United States Patent and Trademark Office

This is the first Office Action for the serial number 09/925,290, STABILIZER FOR OBJECTS SUCH AS CABLES AND WIRES, filed on 8/8/01.

See drawing below from Figure 1 of Kornat's invention and figure 3 from Sparks et al.'s invention:

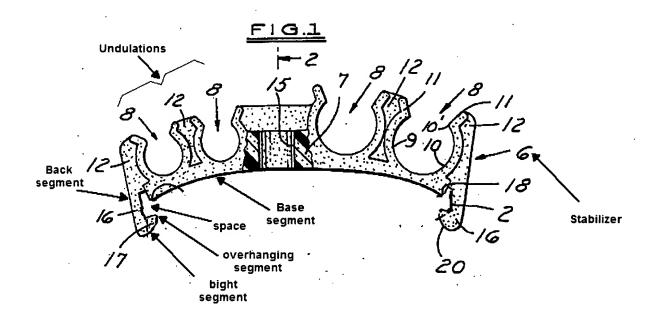
Kornat teaches a stabilizer (6) comprising a first and second hook-like retainer (17) having an overhanging segment, a bight segment, a back segment and a base segment. The overhanging segment having an end spaced from the base segment as to permit entry of the object. The stabilizer further comprises a joinder (8) joining to two base segments and having a plurality of undulations. The retainers are stiffly flexible (plastic, col. 2, lines 17-18) to enable bending of the segments to admit an object. The stabilizer includes a rigid spacer (14) formed between two undulations.

Kornat teaches all elements above but fails to teach a pull rod extending from the second retainer. Sparks et al. teaches the pull rod (located on end of element 30 with rounded like shape) including a stub and laterally extending segments (30). It would have been obvious for one of ordinary skill in the art at the time the invention was made to have added the pull rod to Kornat's second retainer as taught by Sparks et al. to provide convenience for adjusting the stabilizer and releasing an object out of stabilizer by controlling the pull rod.
